Staff Report to the Western Weber Planning Commission

Application Request:	Consideration and action on a request for preliminary plan approval of Winston Park Cluster Subdivision.
Type of Decision:	Administrative
Agenda Date:	Tuesday, May 09, 2017
Applicant:	Jaymak Ogden, LLC
File Number:	LVW040717

The applicant has submitted a request for preliminary plan approval of the Winston Park Cluster Subdivision, a cluster subdivision consisting of 54 building lots, 17 open space parcels, and 3 common areas. The proposed subdivision is located at approximately 3701 West 1800 South, Ogden, UT and is in the A-1 zone. Public roads will be created with this proposal to provide access to each lot and the design will create connectivity to the surrounding area for future development.

UTILITY PLAN

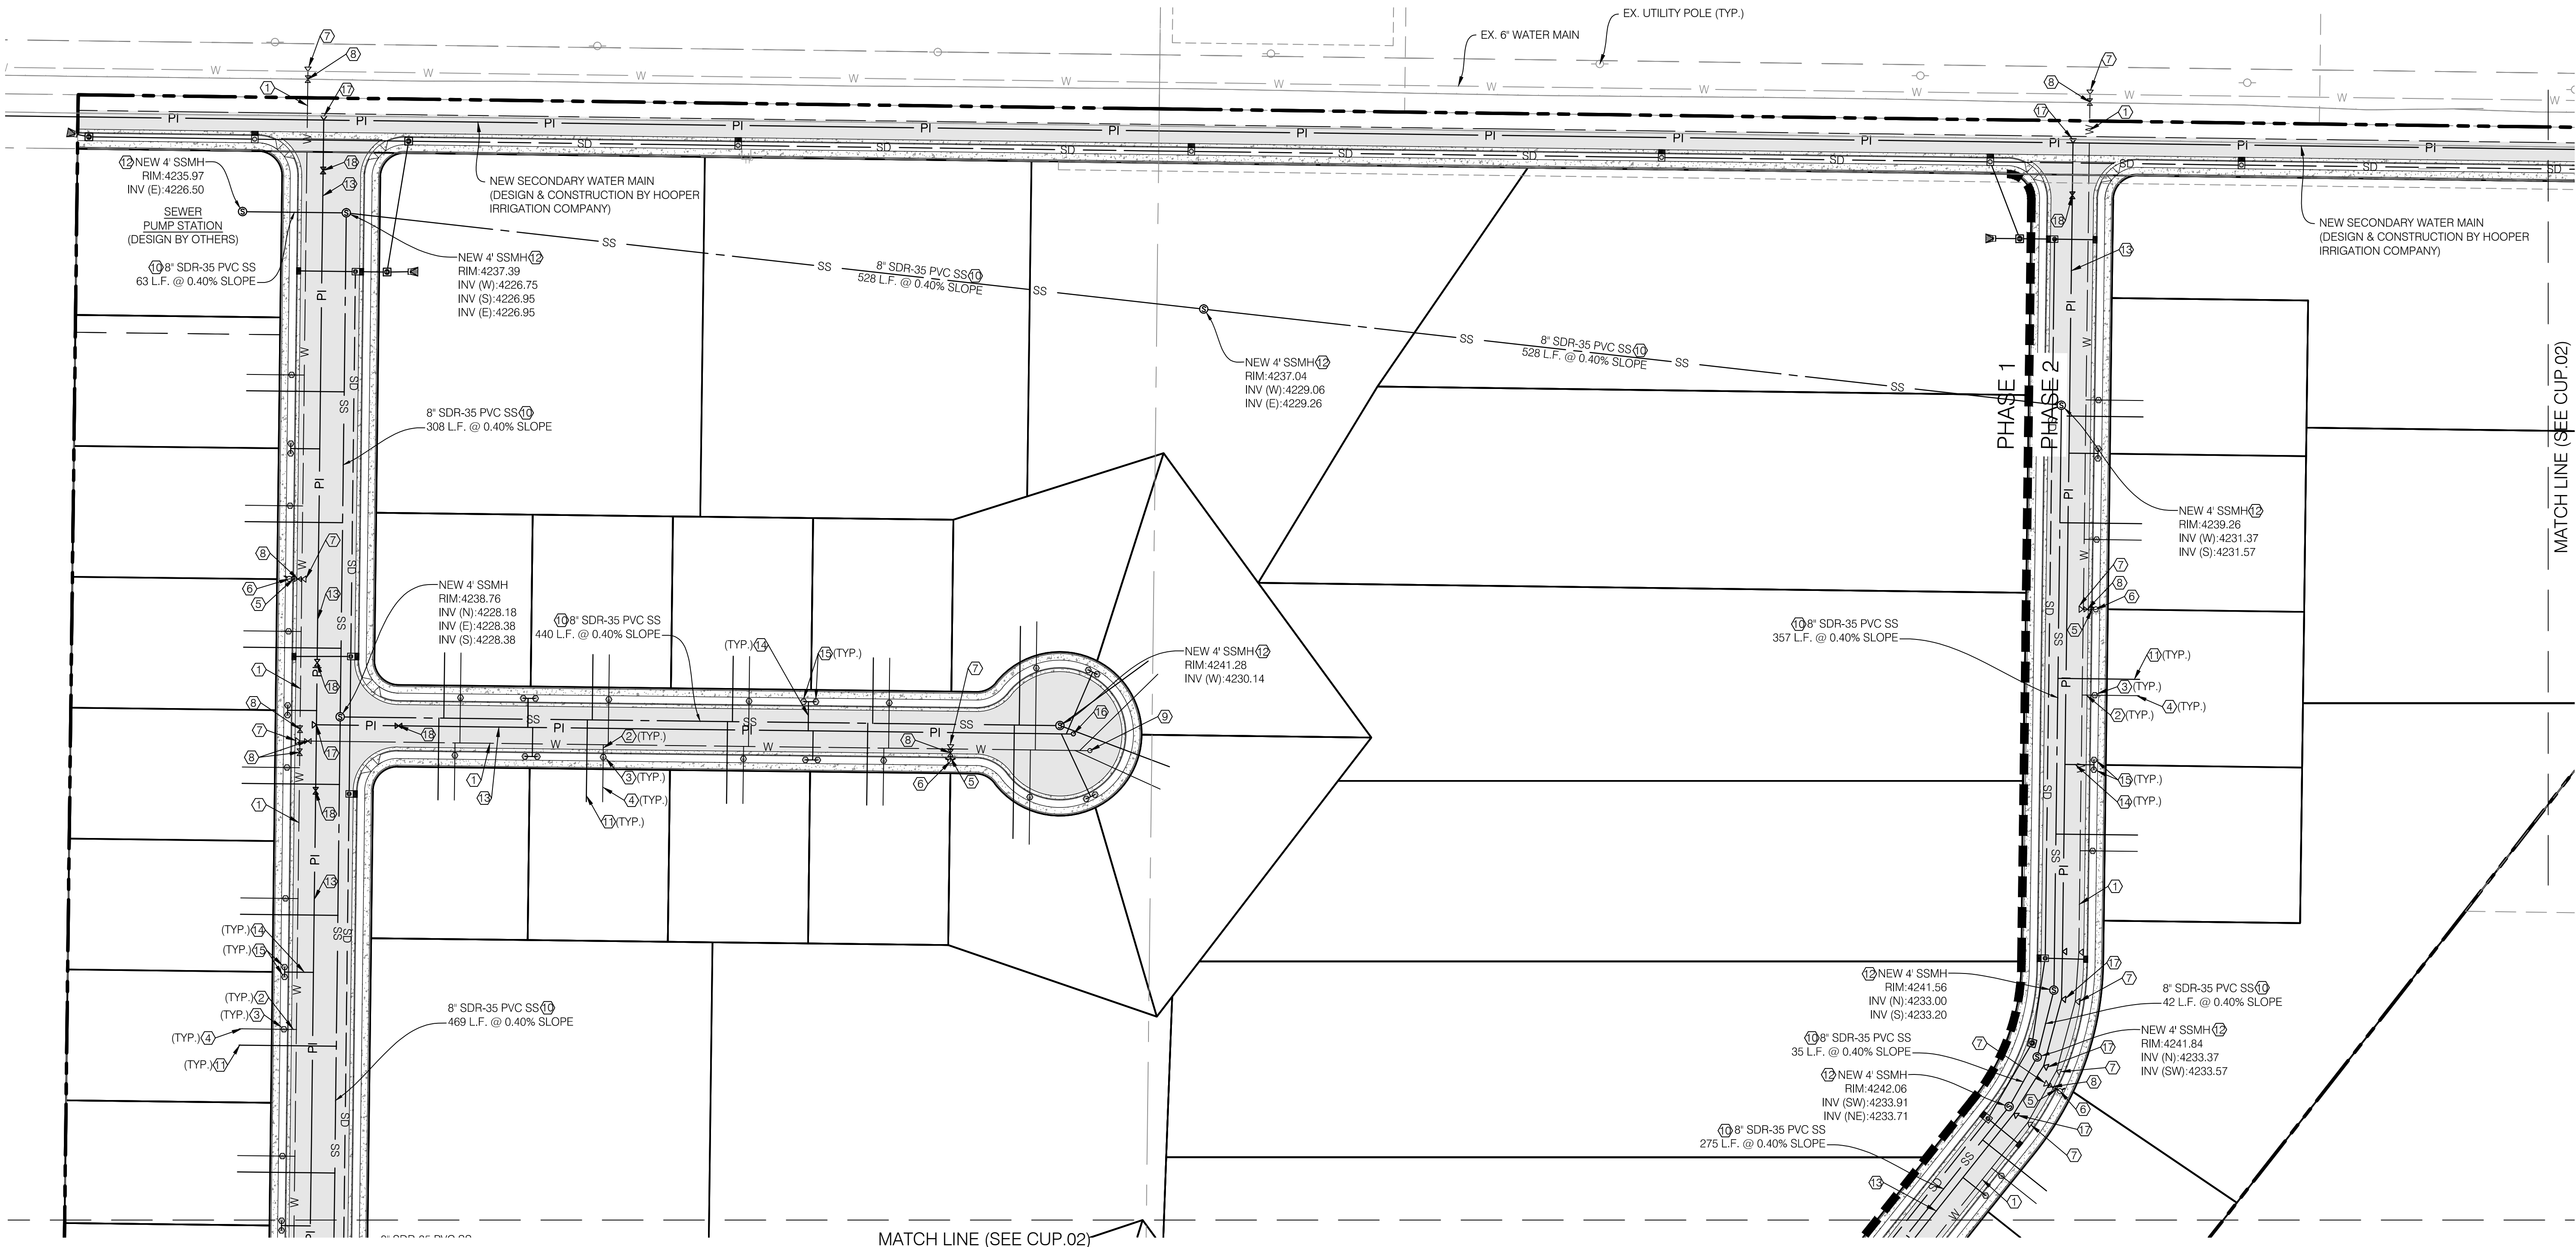
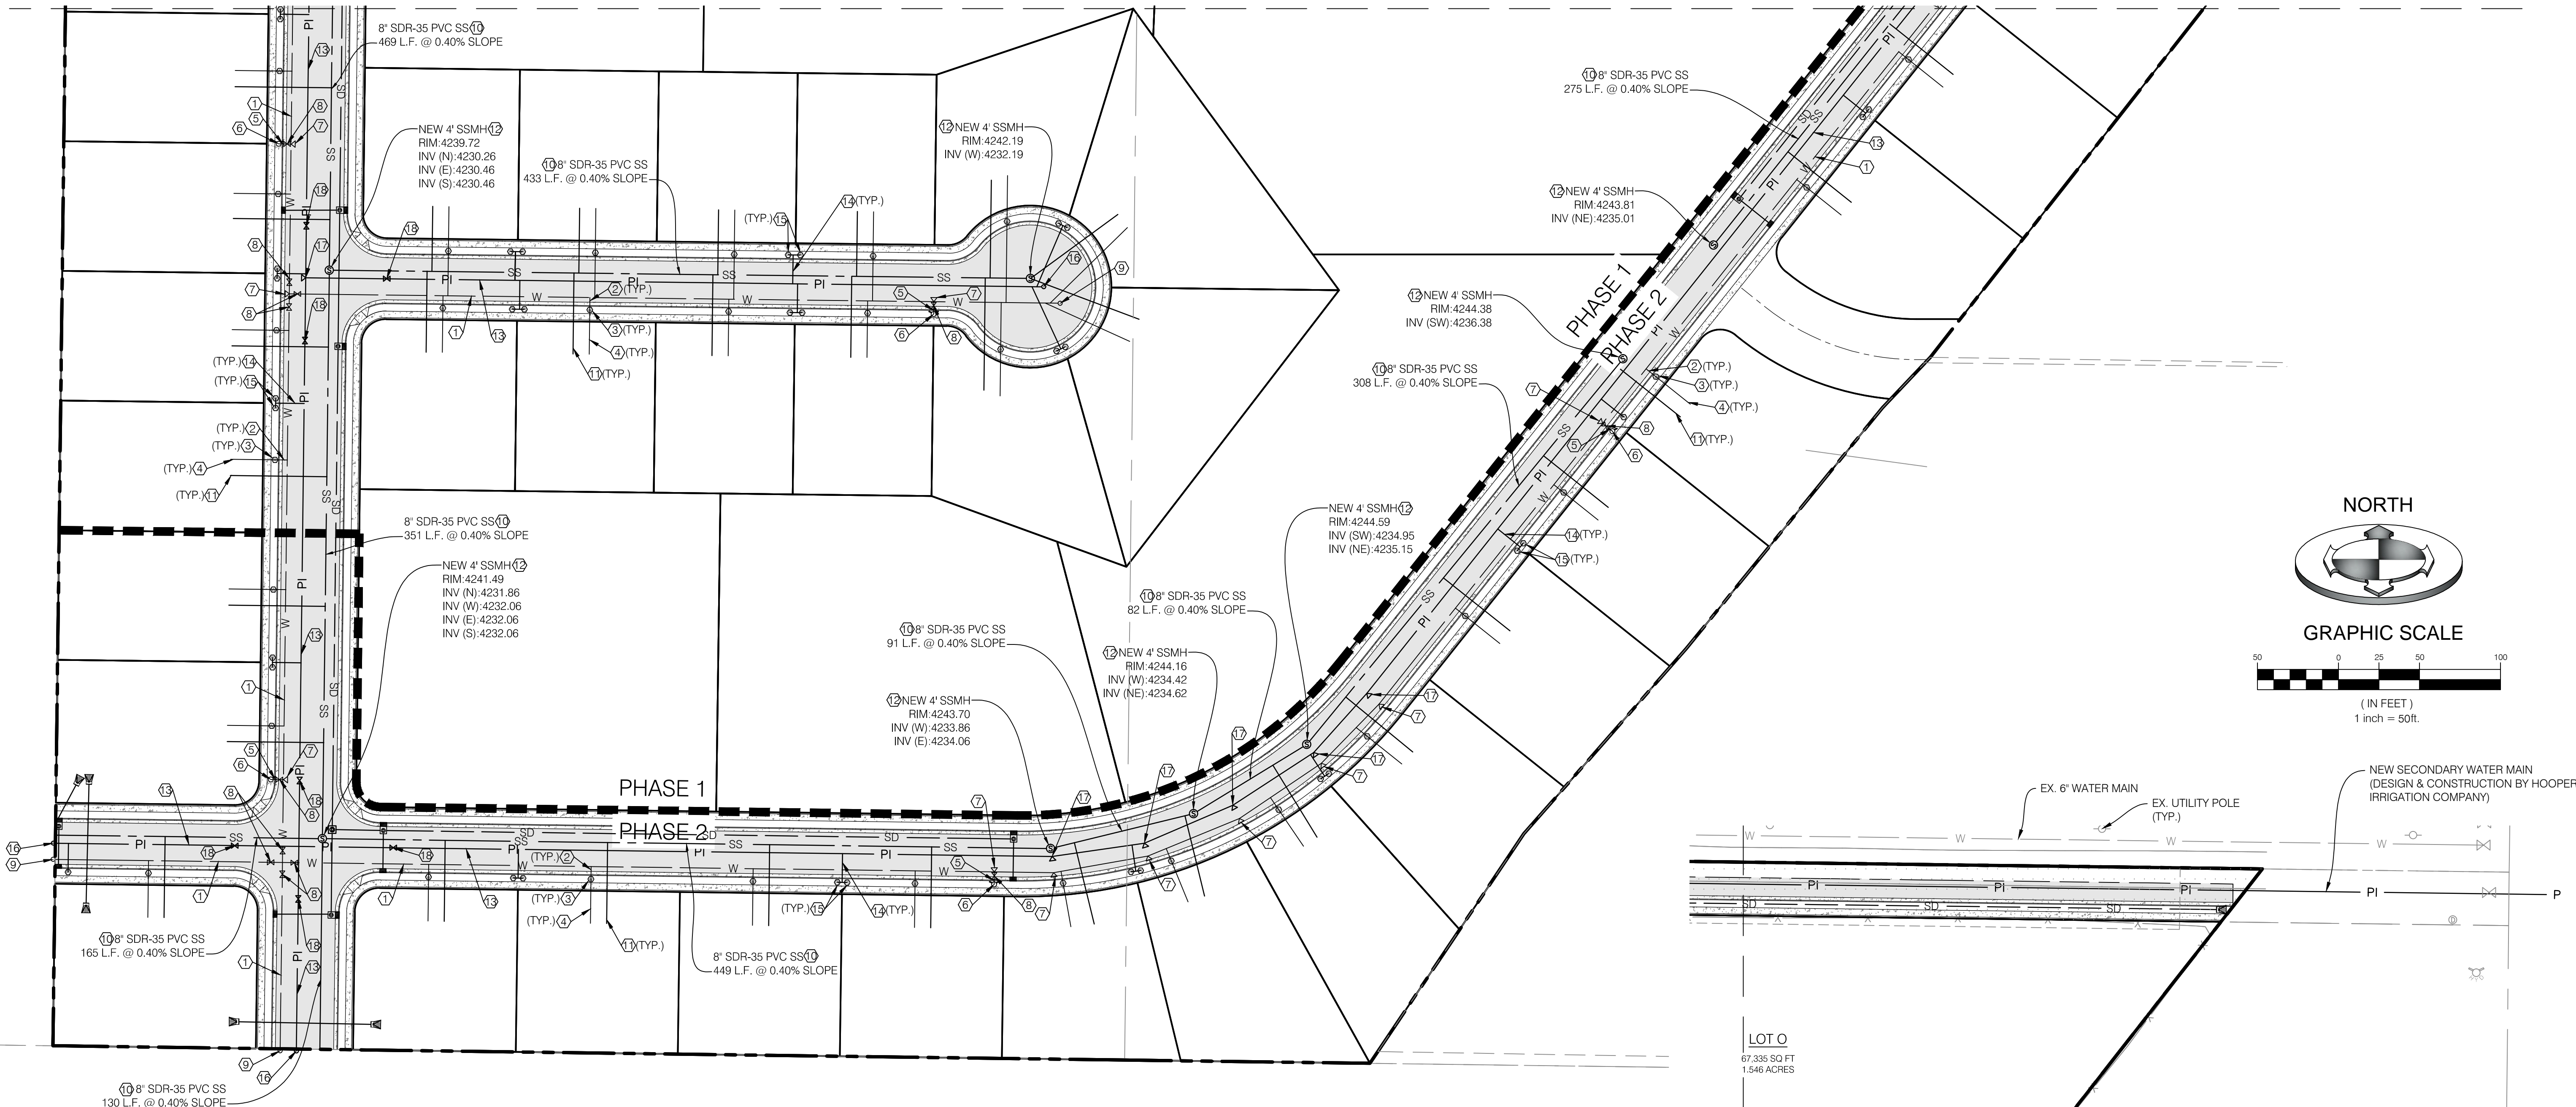
1. The District does not have a gravity flow sanitary sewer line at this location. The closest lines to serve this area are either at the intersection of 1800 South 4300 West or due south of the proposed subdivision on 2200 South. The preliminary utility plans show a sanitary sewer pump station to be constructed in the northwest corner of the subdivision. The connection point from the discharge of the pump station to the District's line is not shown.

3. The District will need to review the location and engineered detail of the point of connection to the District's sanitary sewer lines.
4. The utility drawings indicate a sanitary sewer line being constructed through Agricultural Lots A through E. While the District will not own or maintain these lines we feel there should be a dedicated easement provided to either the County or an entity that will have ownership responsibility for this sewer line.

5. Manholes through the agricultural lots should be raised manholes so groundwater, irrigation water and/or storm water does not enter into the sanitary sewer system. No

buildings or structures should be constructed over the sewer line or within the easement that runs through the agricultural lots.
